**APPROVED MINUTES OF THE REGULAR SESSION OF THE
BUILDING BOARD OF APPEALS OF THE CITY OF ANN ARBOR
January 13, 2010 - 1:30 P.M. – 100 NORTH FIFTH AVENUE, SECOND FLOOR,
CITY COUNCIL CHAMBERS.**

**Figure R311.4.3
THRESHOLD HEIGHTS**

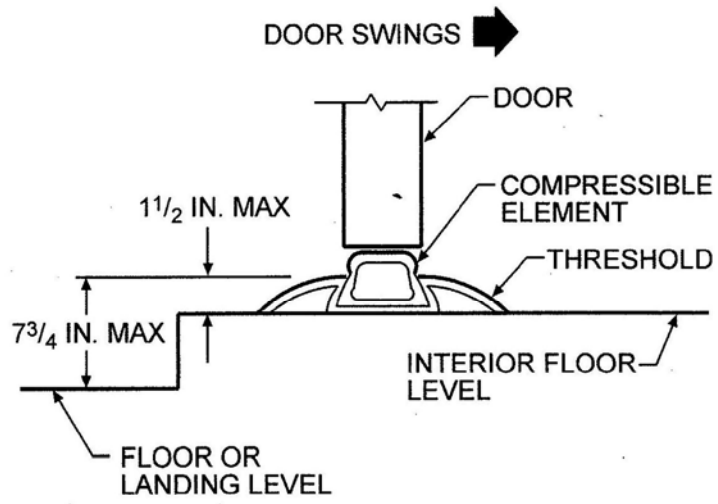
276 Petitioner is constructing a new home. One of the secondary entrances to the home has a set
277 of French doors with the top of the threshold 9 1/2" above the porch. Code allows a maximum
278 of 7 3/4" from the porch to top of the threshold.

310
311 When the inspector was going through the house, he noted that it was higher than the 8 ¼ rise.
312 Either side of that meets the requirements – it's only the flange area that is the barrier. We
313 installed a door and framing during the home construction and the architect drew the plans so
314 that both porches were the same elevation. The other front entry door has no problems. It was
315 done by a different manufacturer as to the sill issue. We're requesting a variance to allow this to
316 stay because of the problems with removing the door, and there is no other door available that
317 is a triple-lock system that meets the 5' width requirement. He stated that he had no other
318 solution for this situation at this time.

325
326 K. Chamberlain (*Fire Marshal*) – If I understand the drawings correctly, the egress path from the
327 inside is free and clear. There is no encumbrance there to speak of. The change would be in
328 stepping down to a lower level. (There is a 1 ½ inch difference between the floor and the flange,
329 so you would be stepping 'over' that flange to step outside.)

334
335 R. Hart – I'm going to ask the obvious – why don't you just get rid of the threshold? (Cut that
336 flange right off?) Yes. The door is set back in a protected area. Just reestablish the drip and
337 knock off the 1 ½". (*Continued discussion between the Board and the Petitioner*)

340
341 Moved by P. Darling, Seconded by R. Hart **"That in the case BBA09-026, 1015 Aberdeen**
342 **Drive, the Board grants a variance from Section R311.4.3 to allow the door threshold not**
343 **to exceed 8 ½ " from the porch elevation to the top of the threshold, provided that two**
344 **other means of egress from the house are provided. This is considered a 'supplemental**
345 **door,' and we find that this meets the intent of the Code."**
